97-04-22

## Model 240R/245R/RX

## Vibration damper

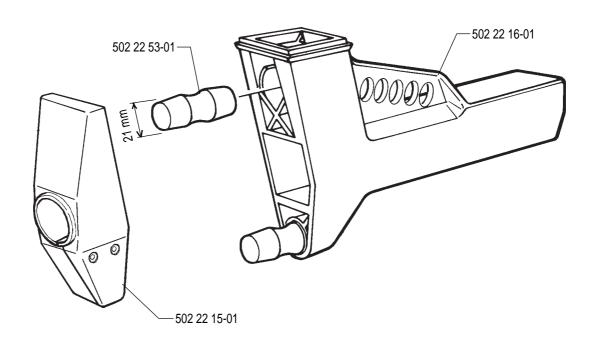
An improved front vibration damper has been introduced for model 240R/245R/RX. The outer diameter of the damper has been increased to 21 mm.

This means that the mounting and holder also have larger recesses for the damper and therefore have new order numbers.

New Ref. No.	Description	Excl. Ref. No.	Remarks
502 22 16-01	Mounting		
502 22 15-01	Holder		
502 22 53-01	Vibration damper

Introduced into production from serial no. 240R = 7080176

245R = 7090256245RX = 7090025
